IEEE 802.3dg Task Force

100BASE-T1L PMA
State Machine Changes

Steffen Graber
Pepperl+Fuchs

Figure 190–16—PHY Control state diagram, part b

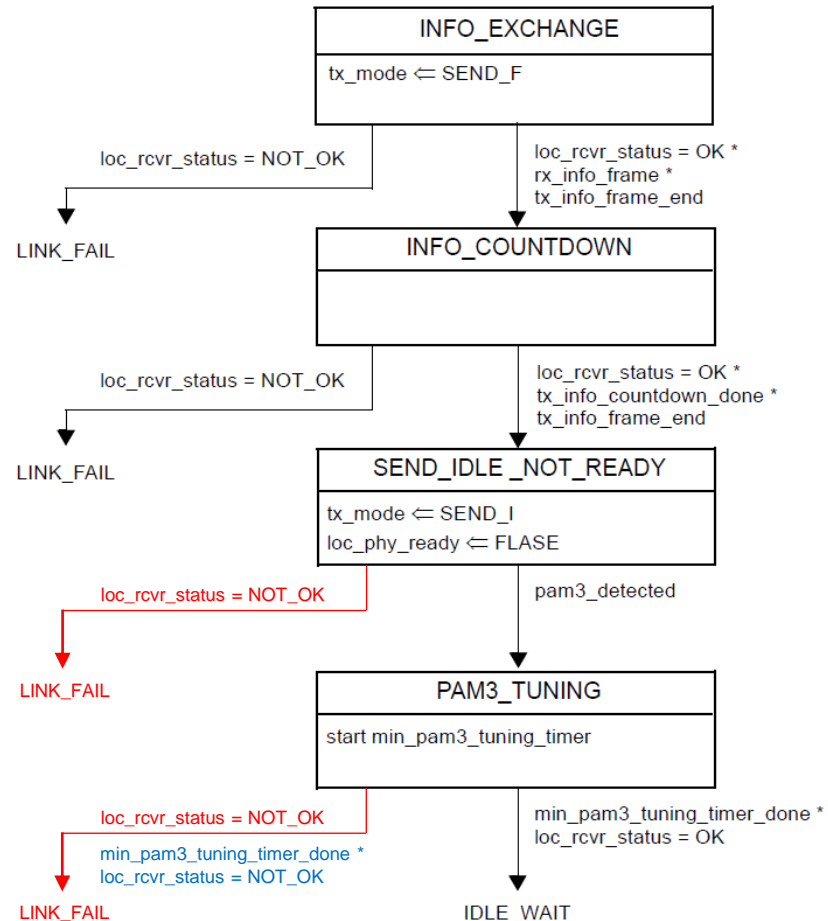
Suggested change to PHY Control State Machine

- If `loc_rcvr_status = NOT_OK`, while in `SEND_IDLE_NOT_READY` or `PAM3_TUNING` states, the PHY Control state machine would stay in one of these states and not go to `LINK_FAIL` state (depending, if PAM3 symbols are detected or not).

- Finally the Auto-Negotiation state machine would bring the PHY Control state machine back to the start condition.
- From all other states the PHY Control state machine would go to `LINK_FAIL` in a similar condition (signaling earlier to the remote PHY that something is wrong by sending zeroes (`SEND_Z`)).

- This could be resolved by adding the two red colored additional exit conditions.
- If a risk is seen, that while switching from PAM2 to PAM3 the local receiver status can temporarily become `NOT_OK`, it makes sense, not to go to `LINK_FAIL` directly and allow the tuning timer to elapse first (in this case omitting the exit condition to `LINK_FAIL` in `SEND_IDLE_NOT_READY` state and using the blue colored, instead of red colored, exit condition in `PAM3_TUNING` state could make sense as alternative).

- Change exit condition of PAM2_TRAINING_WAIT state to:

$\text{loc_rcvr_status} = \text{OK} * ((\text{config} = \text{LEADER} * \text{rem_rcvr_status} = \text{OK}) + (\text{config} = \text{FOLLOWER} * \text{rx_info_frame}))$

- In SEND_IDLE state loc_phy_ready is set to TRUE. This results in the far end PHY signaling rem_phy_ready = TRUE. If both PHYs signal ready, then normal operation (state SEND_IDLE_OR_DATA) can start. Exit condition of SEND_IDLE state needs to be changed to:

$\text{loc_rcvr_status} = \text{OK} * \text{rem_phy_ready}$

- If either loc_rcvr_status = NOT_OK or pma_refresh_status = FAIL, the link should be restarted. Exit condition of SEND_IDLE_OR_DATA state needs to be changed to:

$\text{loc_rcvr_status} = \text{NOT_OK} + \text{rem_refresh_status} = \text{FAIL}$

Figure 190-19—EEE Refresh monitor state diagram

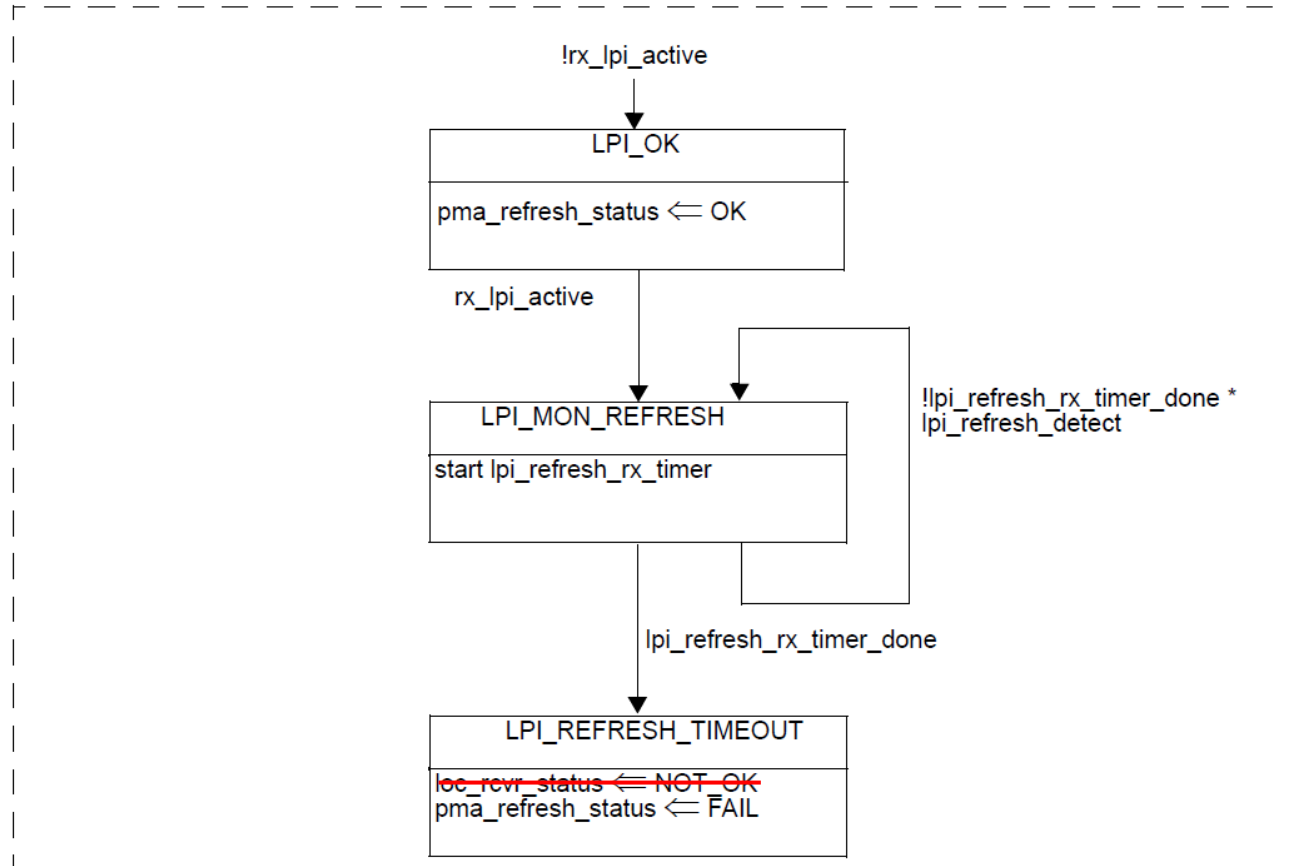
Suggested change to EEE Refresh Monitor State Machine

- `loc_rcvr_status` is generated by PMA receive function.
- Thus, the EEE refresh monitor is not expected to have write access to this variable in parallel to the PMA Receive function, as this may end up in a conflict.
- Setting `pma_refresh_status` `<= FAIL` should be enough to do, as by setting this variable, the PHY Control state machine exits `SEND_IDLE_OR_DATA` state to `LINK_FAIL` state, which brings the link down by sending zeroes (and causes the same behavior as setting `loc_rcvr_status` to `NOT_OK`).
